Project	IEEE 802.16 Broadband Wireless Access Working Group < <a href="http://ieee802.org/16">http://ieee802.org/16</a> >	
Title	<b>Primitives for Radio Resource Management (RRM)</b>	
Date Submitted	2005-07-19	
Source(s)	Torsten Fahldieck Alcatel Achim Brandt Siemens	Voice: +49 711 82132163 Email: <a href="mailto:torsten.fahldieck@alcatel.de">torsten.fahldieck@alcatel.de</a>  Voice: +49 89 636 75189, (mob) +49 172 8402655 Email: <a href="mailto:achim.brandt@siemens.com">achim.brandt@siemens.com</a>
Re:	Call for comments	
Abstract	In this contribution, several primitives for Radio Resource Management are defined, as well as corresponding extensions of MAC management messages.	
Purpose	Adoption	
Notice	This document has been prepared to assist IEEE 802.16. It is offered as a basis for discussion and is not binding on the contributing individual(s) or organization(s). The material in this document is subject to change in form and content after further study. The contributor(s) reserve(s) the right to add, amend or withdraw material contained herein.

# Primitives for Radio Resource Management

### 4 Proposed Text Changes

**Figure 1: Example Primitive Flow of Physical Parameter Report**

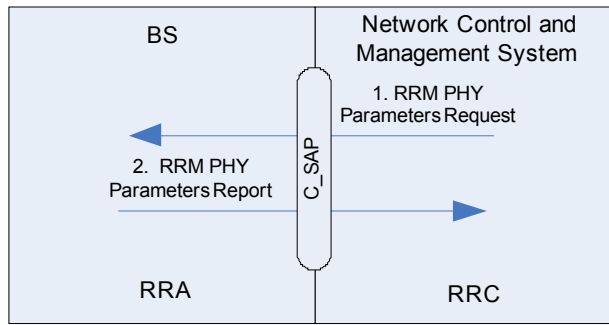
Proposal #1: Modify section 14.5.12 to have the contents as follows.

**14.5.12.1.1.4 RRM PHY report primitive**

The BS may use this primitive to provide a report of the link level quality for a specific MS to the Radio Resource Controller (RRC).

**Figure 2: Example Primitive Flow of Spare capacity Report**

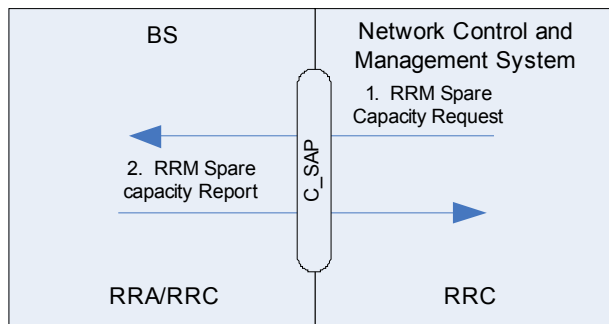
##### 14.5.12.1.1.1 RRM Spare Capacity Request Primitive

The Radio Resource Controller (RRC) may use this primitive to request a BS to provide spare capacity information to the RRC. Note that the RRC may be located in another BS, or in a central entity in the NCMS.

##### 14.5.12.1.1.2 Spare capacity report primitive

The BS may use this primitive to provide spare capacity information to the RRC, as requested by the RRC within the Spare Capacity Request Primitive.

**Figure 3: Example Primitive Flow of Radio Resource Status Update**

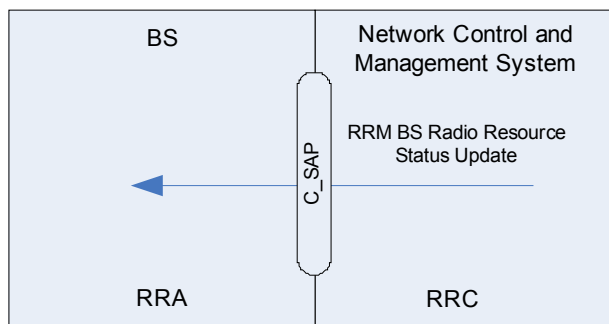
**14.5.12.1.1.5 RRM Neighbor-BS Radio Resource Status Update primitive**

This primitive can be used by RRC to inform a Serving BS about the list of Neighbor BS's which are potential HO Target Base Stations for any MS's being served by the SBS, including an information about their radio resource status
